H. B. ROBINSON STEAM ELECTRIC PLANT, UNIT NO. 2  
DOCKET NO. 50-261/LICENSE NO. DPR-23

RESPONSE TO REQUEST FOR ADDITIONAL INFORMATION RELATED TO REQUEST FOR RELIEF FROM ASME BOILER AND PRESSURE VESSEL CODE, SECTION XI, SUBSECTIONS IWE AND IWL REQUIREMENTS FOR CONTAINMENT INSPECTIONS

**RESPONSE TO REQUESTS FOR ADDITIONAL INFORMATION**

FIGURE 1

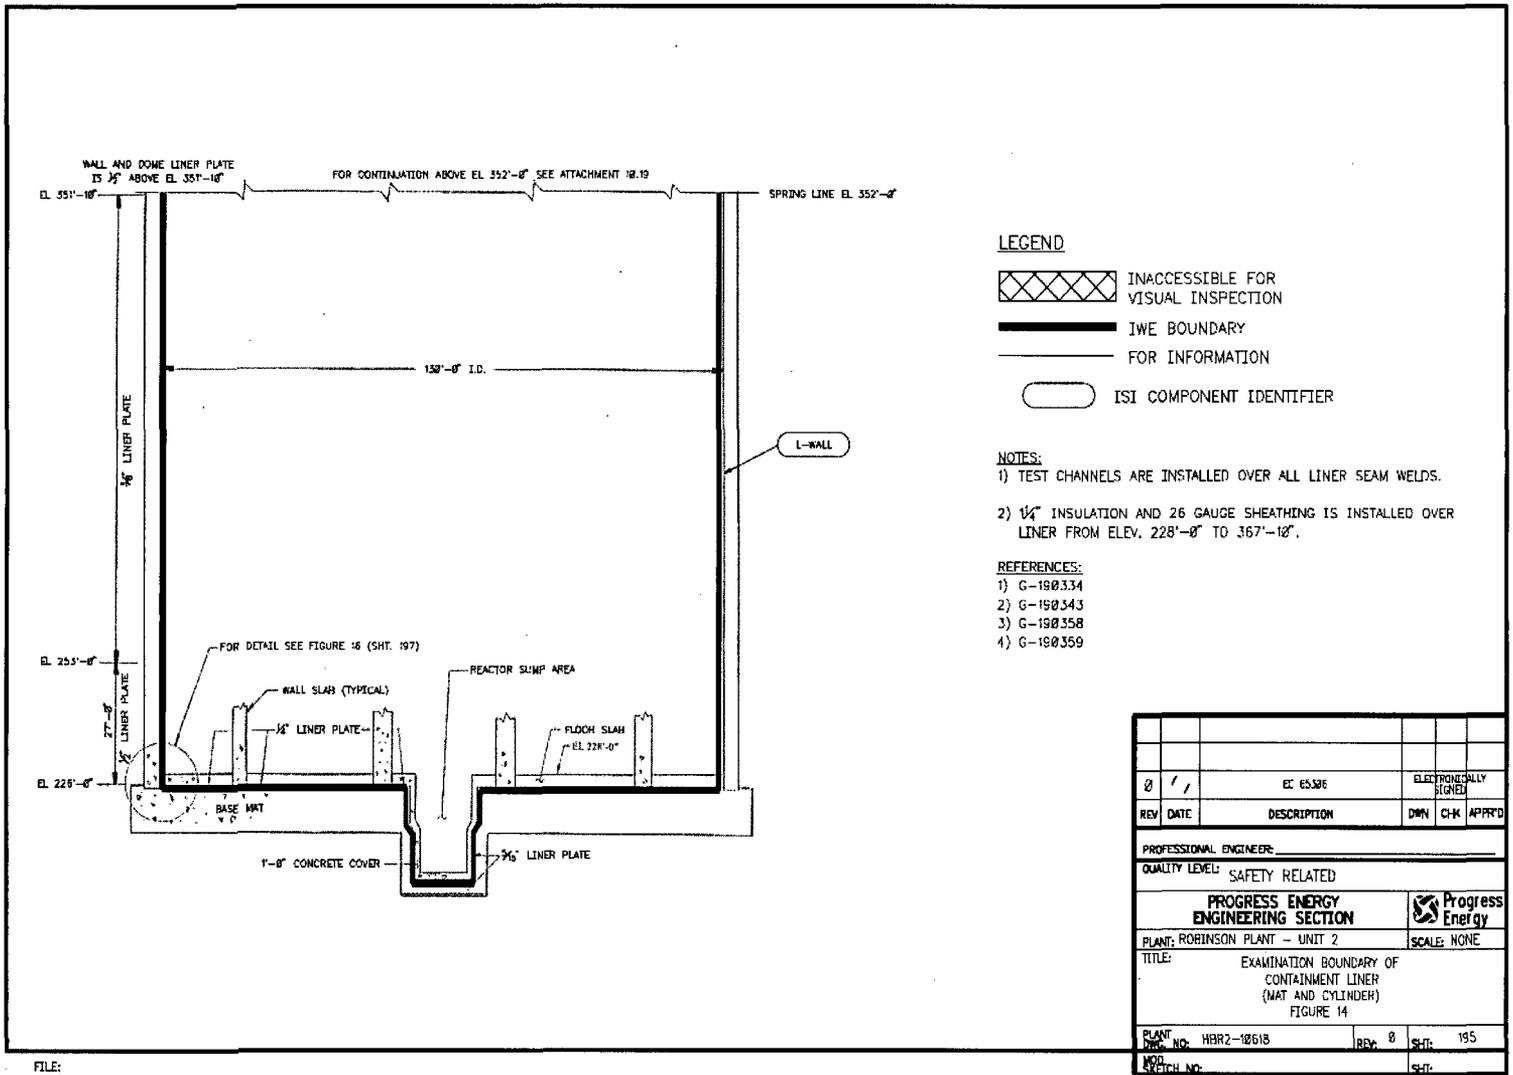
RR IWE/IWL-RR-01 requests relief from the requirements of Table IWE-2500-1, Examination Category E-A, Item E1.11 of the ASME Code Section XI, 2001 Edition and 2003 addenda. This item requires a general visual examination of 100 percent of the accessible surfaces of containment during each period of the inspection interval in order to assess the general condition of containment surfaces and facilitate early detection of degradation that may affect containment structural integrity and/or leak-tightness. The "Alternative Examination(s)" section of RR IWE/IWL-RR-01 states that "the alternative examination proposed is to perform a general visual examination on those portions of the insulated containment liner that are exposed when a maintenance activity requires removal of the liner insulation. This examination will be completed if not previously performed in the inspection interval."

The proposed alternative, as written, could preclude any examination of portions of the containment liner during the inspection interval if there is no maintenance activity that requires removal of the liner insulation in that area. The licensee did not provide a list or schedule of planned maintenance activities to be performed during the inspection interval that would require removal of the insulation panels, thus enabling liner examination. Furthermore, the licensee does not identify target areas where these insulation panels would be removed and the liner examined. Also, there is no commitment on the part of the licensee to perform the general visual examination of at least the critical areas of the insulated containment liner by sampling a reasonable percentage of the inspection areas during the second 10-year containment ISI interval, as was done when similar relief was authorized for the first containment ISI interval.

Therefore, the staff has determined that the proposed alternative, as written, does not provide an acceptable level of quality and safety as required by 10 CFR 50.55a(a)(3)(i). The staff finds that in order for the proposed alternative to meet the requirements of 10 CFR 50.55a(a)(3)(i), the alternative should, as a minimum, commit to perform a general visual examination of critical areas of the insulated containment liner (e.g. the containment wall liner lower areas near the basemat, around openings and penetrations, structural discontinuities, etc.) at least once during the inspection interval by removing a reasonable sample of the insulation panels covering critical areas in order to facilitate liner inspection. Portions of the insulated containment liner that are exposed when a maintenance activity requires removal of the liner insulation may be included in the sample. Based on the above discussion, the licensee is requested to revise its proposed alternative examination to include

a commitment to perform a general visual examination of the containment liner and to identify the areas within the containment liner that would be included in future examination.

This request for relief is applicable to the insulated portion of the containment liner classified as Class MC and subject to the requirements of Table IWE-2500-1, Examination Category E-A, at the H. B. Robinson Steam Electric Plant (HBRSEP), Unit No. 2 (Figure 1).

Currently, the IWE/IWL Program/Plan identifies 62 insulation panels at the interface between the concrete and the containment base mat (228-foot Elevation). Approximately one-third of the panels at the base mat interface will be removed and a general visual examination of the containment liner performed each examination period during the Second Ten-Year Interval. This will ensure that over the Second Ten-Year Interval, a 100% general visual examination of the liner at the base mat elevation will be performed.

In addition, during the Second Ten-Year Interval, when an insulation panel at any elevation is removed for maintenance activities, a general visual examination of the liner beneath that panel will be performed.

FIGURE 2

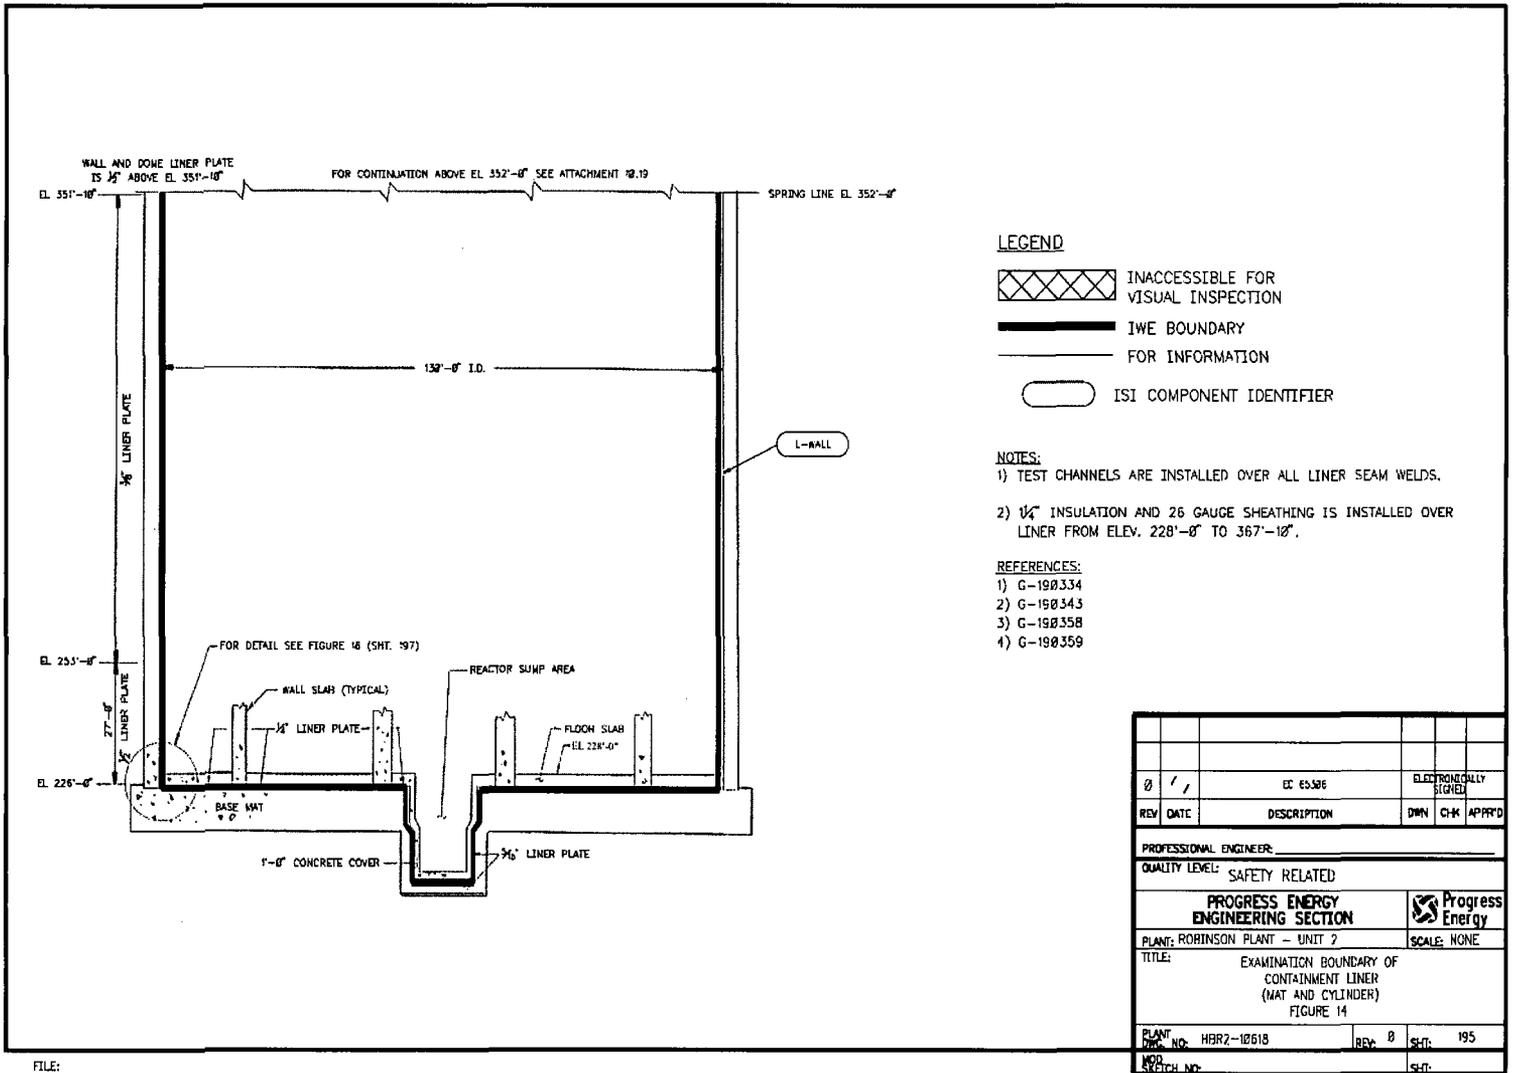
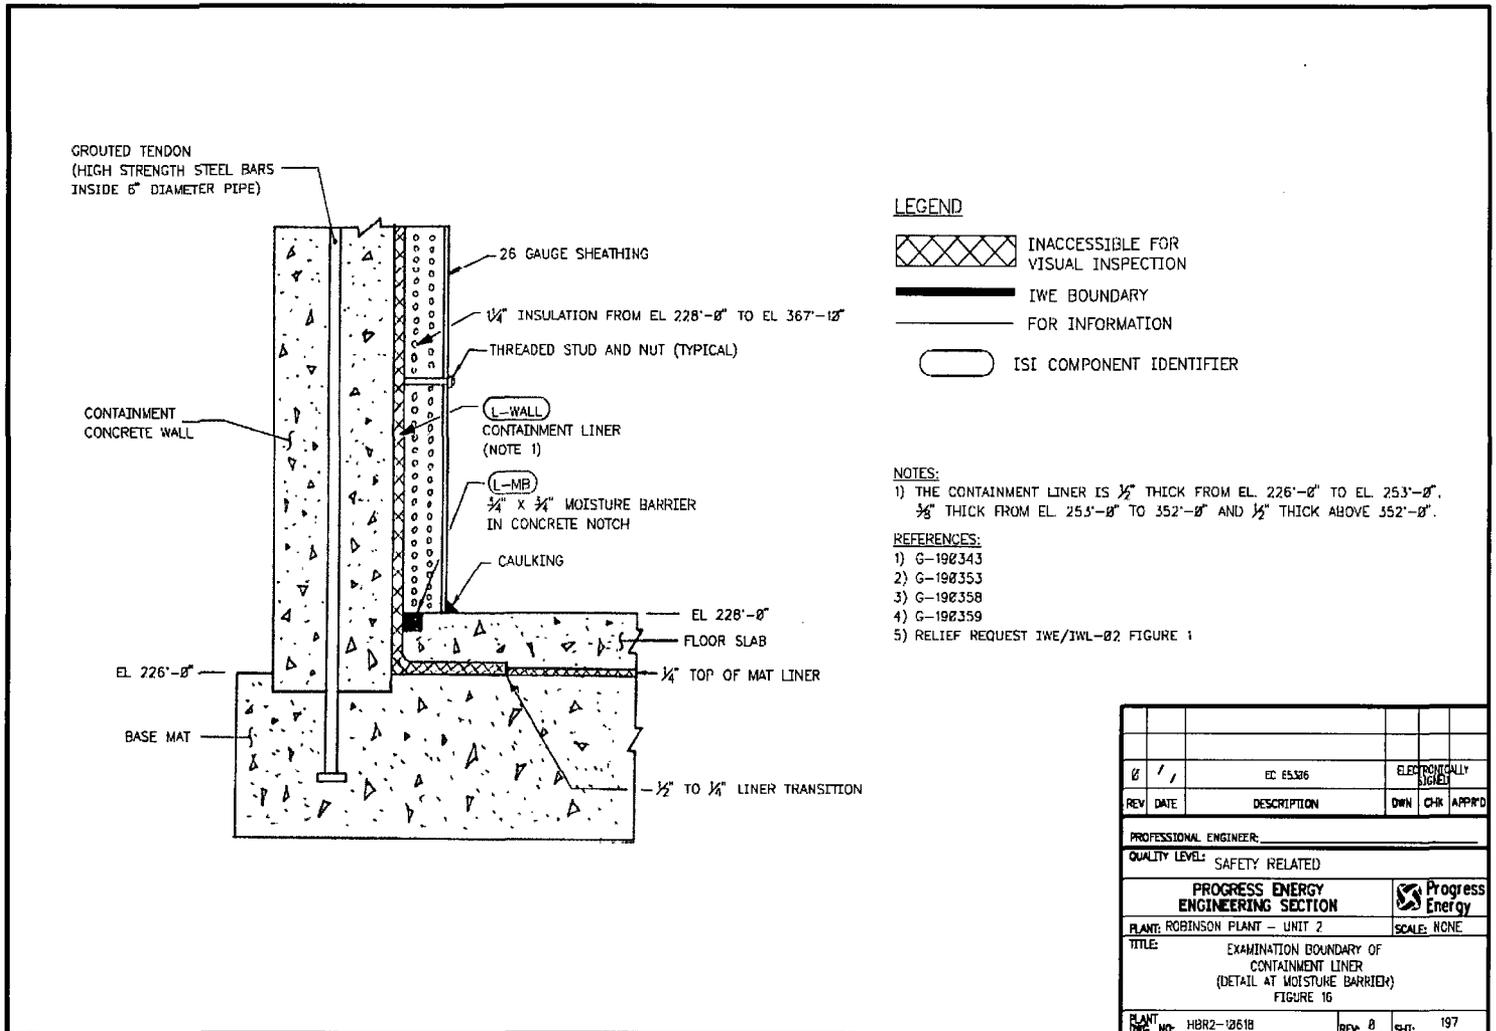
RR IWE/IWL-RR-02 requests relief from the requirements of Table IWE-2500-1, Examination Category E-A, Item E1.30 of the ASME Code Section XI, 2001 Edition and 2003 addenda. This item requires a general visual examination of 100 percent of the containment moisture barriers during each period of the inspection interval in order to detect/prevent intrusion of moisture against the containment liner. The "Alternative Examination(s)" section of RR IWE/IWL-RR-02 states that "the alternative examination to the 100 percent per period general visual examination of the containment moisture barriers is to perform a general visual examination on those portions of the 228-foot elevation concrete-to-metal liner moisture barrier that are exposed when a maintenance activity requires removal of the associated barrier insulation."

The proposed alternative, as written, could preclude any examination of portions of the moisture barrier during the inspection interval if there is no maintenance activity that requires removal of the lower row liner insulation in that area. The licensee did not provide a list or schedule of planned maintenance activities to be performed during the inspection interval that would require removal (with extent) of the lower row insulation panels, thus allowing moisture barrier examination, as was done when similar relief was authorized for the first containment ISI interval. Furthermore, the licensee takes credit for the insulation covering the liner and moisture barrier as providing an additional moisture barrier, but has not committed to perform any general visual examination of the caulking/water seal (which act as a secondary moisture barrier) near the insulation-concrete slab interface at elevation 228 feet.

Therefore, the staff has determined that the proposed alternative, as written, does not provide an acceptable level of quality and safety as required by 10 CFR 50.55a(a)(3)(i). The staff finds that in order for the proposed alternative to meet the requirements of 10 CFR 50.55a(a)(3)(i), the alternative should, as a minimum, commit to perform a general visual examination of 100 percent of the caulking sealant and water seals at or near the insulation-concrete slab interface at elevation 228 feet (see Figure 2 contained in the licensee's submittal) during each inspection period of the second containment ISI interval. Further, the moisture barrier at the concrete-to-containment liner interface should be subject

to a general visual examination at least once during the second containment ISI interval when the lower row insulation panels are removed for maintenance activities and/or examination of the liner, per the alternative examination for RR IWE/IWL-RR-01 discussed in RAI 2. Considering the above, the licensee is requested to revise its proposed alternative examination to address the stated concern.

This request for relief is applicable to components classified as Class MC and subject to the requirements of Table IWE-2500-1, Examination Category E-A, at the H. B. Robinson Steam Electric Plant (HBRSEP), Unit No. 2 (See Figure 2).

The IWE/IWL Program/Plan identifies 62 insulation panels at the interface between the concrete and the containment base mat (228-foot Elevation). Approximately one-third of the panels at the base mat interface will be removed and a general visual examination of the moisture barrier performed each examination period during the Second Ten-Year Interval. This will ensure that over the Second Ten-Year Interval, a 100% general visual examination of the moisture barrier will be performed.

Additionally, during the Second Ten-Year Interval, when an insulation panel on the 228-foot Elevation is removed for maintenance activities, a general visual examination of the moisture barrier will be performed.

As shown in Figure IWE-2500-1, and noted in Table IWE-2500-1, moisture barrier materials are intended to prevent intrusion of moisture against inaccessible areas of the pressure-retaining metal containment shell or liner at concrete-to-metal interfaces and at metal-to-metal interfaces which are not seal-welded. For HBRSEP, Unit No. 2, the moisture barrier that meets this definition is the epoxy joint filler that interfaces with the concrete-to-containment liner interface at the 228-foot Elevation. Figures 1 and 2 provide details of that interface.
